APPENDIX E

PERRY COUNTY'S FACILITIES EVALUATIONS, FINDINGS AND PHOTOS

Curb ramp – from Northeast toward Entrance

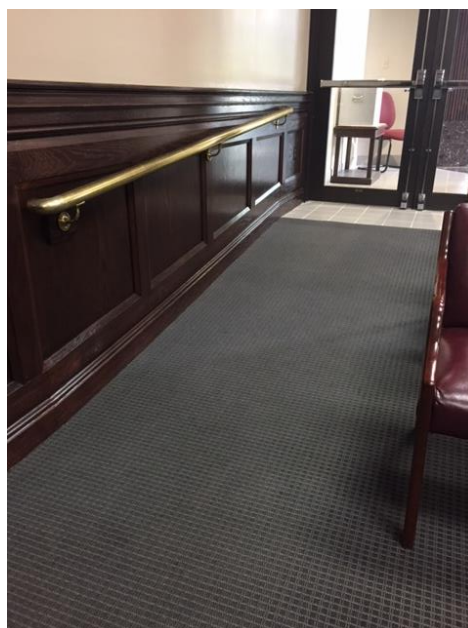
Landing at top of curb ramps is less than 36 inches long.

Reconfigure to add a minimum 36-inch level landing at top of all curb ramps.

Parking spaces

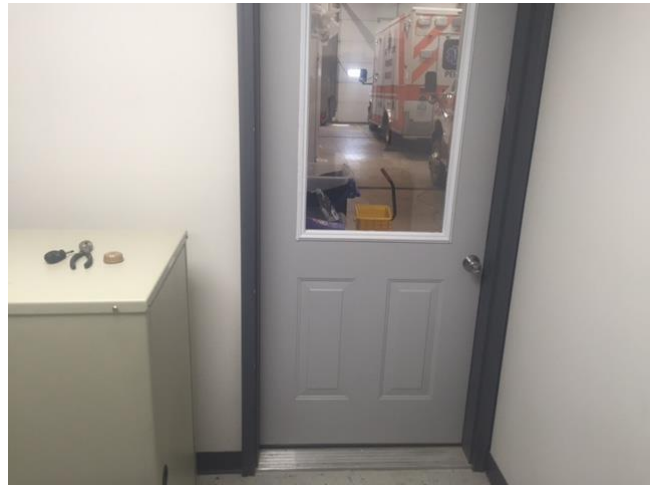
There is not at least 1 van accessible parking space.

Accessible spaces must be at least 8' wide with an access aisle at least 5' wide.

Van accessible space must be either 11' wide with an access aisle at least 5' wide or 8' wide with an access aisle at least 8' wide.

Access aisle is not marked.

Reconfigure parking area by painting lines designating 1 accessible van space.

Reconfigure parking area by painting lines designating accessible spaces.

Reconfigure one of the existing parking spaces so that it meets the minimum required widths of a van accessible space.

Mark access aisles to discourage parking in them.

Information counter (2nd Floor)

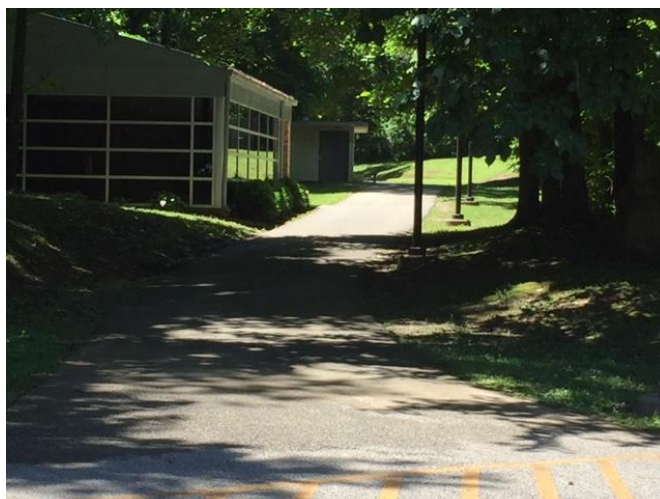
Information counter does not have a portion that is no higher than 36" above the floor and 36" long.

Lower section of counter top.
